REVIEW OF SOIL-STRUCTURE INTERACTION AND
SEISMIC ANALYSIS OF CATEGORY I STRUCTURES
SOUTH TEXAS PROJECT
UNITS 1 & 2

January 1981
2 comments

SOUTH TEXAS PROJECT
UNITS 1 & 2

UNIT 1 ELEMENT VIEW
CROSS SECTION 1
FIGURE 4.3-4

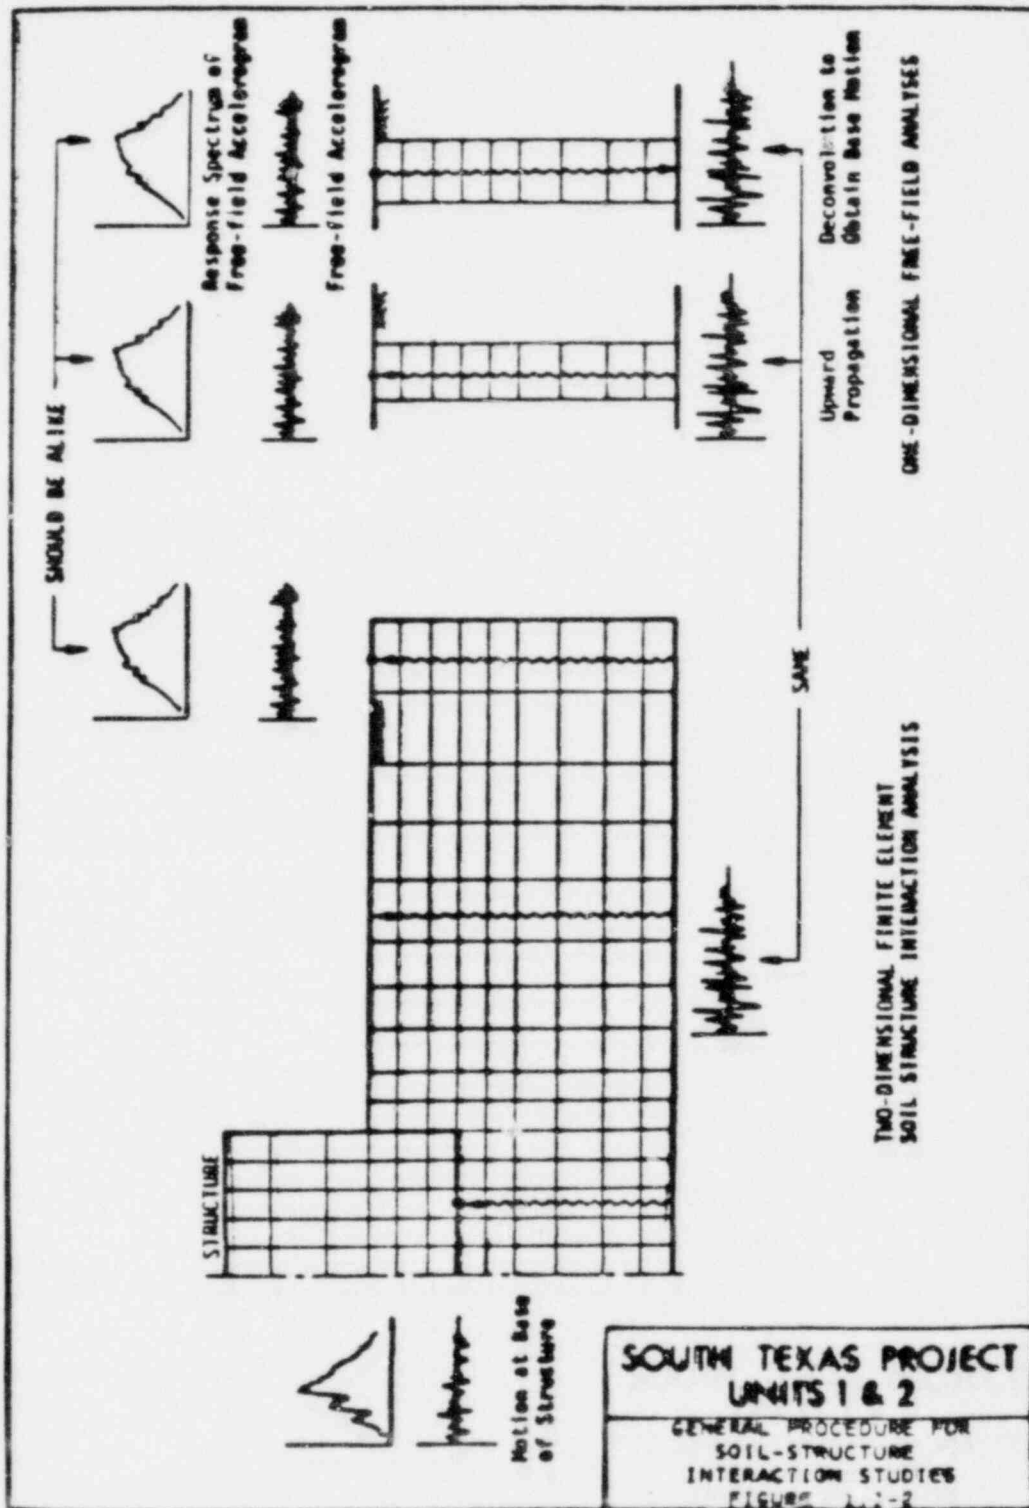
APPLICABILITY OF FEM TO STP SITE

- Layered Foundation Materials
- Deeply Embedded Structures
- Close Proximity of Structures
- Control Motion at Finished Grade
- Parametric Studies on Soil Properties
- Enveloped 60% Design Response Spectra at Foundation Level

COMPARISON OF FOUNDATION-LEVEL
MOTION RESPONSE SPECTRA WITH
NRC CRITERIA, HORIZONTAL OBE
FIGURE 9.6-2

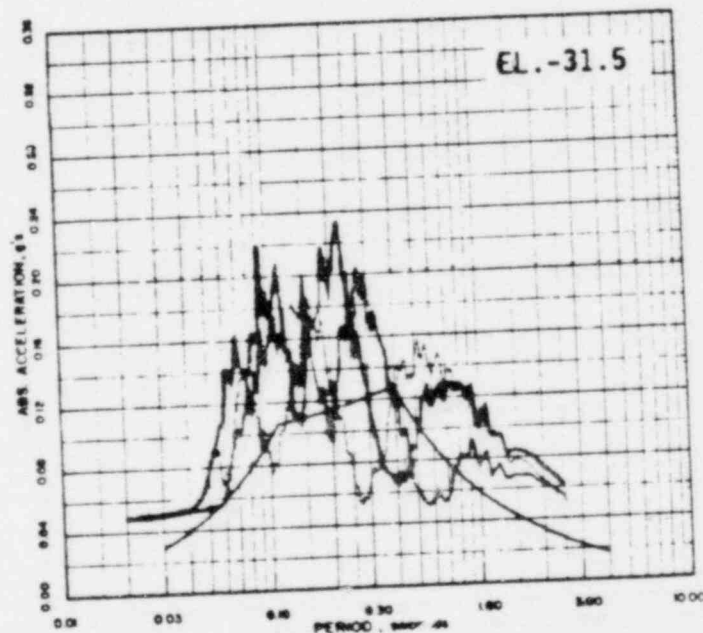
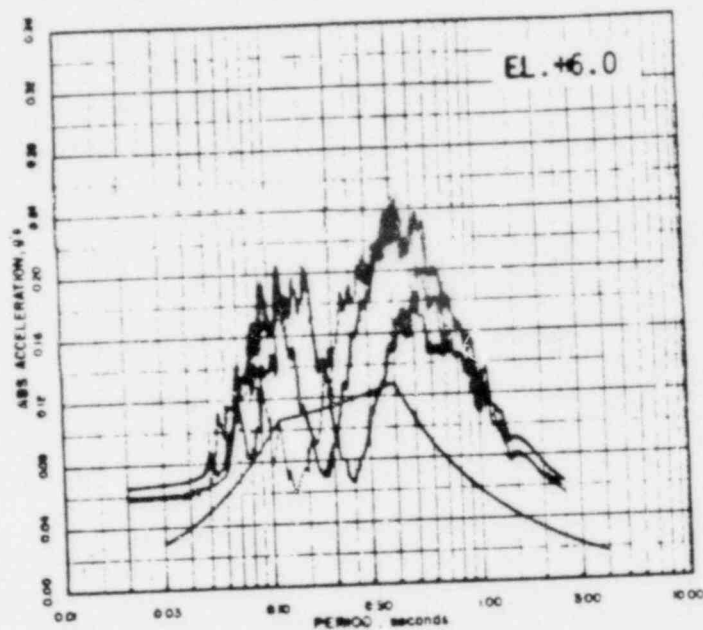
- THE CHOICE OF 0.10G FOR THE SSE AND 0.05G FOR THE OBE APPEARS TO BE QUITE CONSERVATIVE FOR THE LOCATION OF THE STP
- THE TIME SERIES OF ACCELERATION USED FOR THE SSI ANALYSES HAVE RESPONSE SPECTRA WHICH ARE AT OR ABOVE THE TARGET SPECTRA IN THE COMPLETE RANGE OF FREQUENCIES OF INTEREST, FOR ALL VALUES OF DAMPING
- ADDITIONAL CONSERVATISM IN THE INPUT MOTIONS WAS INTRODUCED IN ORDER TO COMPLY WITH CERTAIN REQUIREMENTS ON THE FREE-FIELD PEAK ACCELERATION AT THE FOUNDATION OF THE DEEPEST BUILDING AND UPON THE RESPONSE SPECTRA AT THIS ELEVATION
- THE PROCEDURE FOR ASSIGNING BASE MOTIONS TO THE DIESEL GENERATOR BUILDING AND FUEL HANDLING BUILDING IS DEFINITELY CONSERVATIVE
- THE ANALYSIS PROCEDURE USED RESULTS IN CONSERVATIVE FLOOR RESPONSE SPECTRA
- THE SPECTRAL PEAKS FOR VERTICAL INPUT MOTION DUE TO THE VERTICAL OBE ARE CONSERVATIVELY HIGH
